RBG-46606

SUBJECT: License Amendment Request
Application for Technical Specifications (TS) Change Regarding Mode
Change Limitations (TSTF-359) Using the Consolidated Line Item
Improvement Process (CLIIP), and Correct Example 1.4-1 (TSTF-485)
River Bend Station, Unit 1
Docket No. 50-458
License No. NPF-47

Attachment 1

Description and Assessment

E.1 and E.2

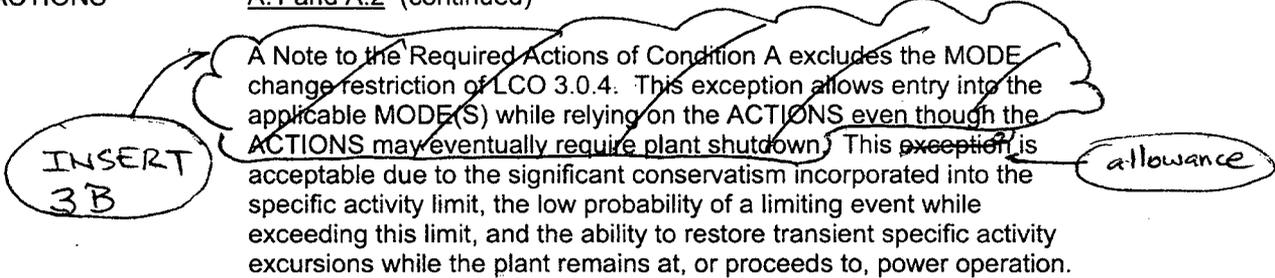
With both the gaseous and particulate drywell atmospheric monitor channels and the drywell air cooler condensate flow rate monitor inoperable, the only means of detecting LEAKAGE is the drywell floor drain sump monitoring system. This Condition does not provide the required diverse means of leakage detection. The Required Action is to restore either of the inoperable monitoring systems to OPERABLE status within 30 days to regain the intended leakage detection diversity. The 30 day Completion Time ensures that the plant will not be operated in a degraded configuration for a lengthy time period. The Required Actions

are modified by a Note that states that the provisions of LCO 3.0.4 are not applicable. As a result, a MODE change is allowed when both the drywell gaseous and particulate atmospheric monitoring channels and drywell air cooler condensate flow rate monitoring system are inoperable. This allowance is provided because other instrumentation is available to monitor RCS leakage.
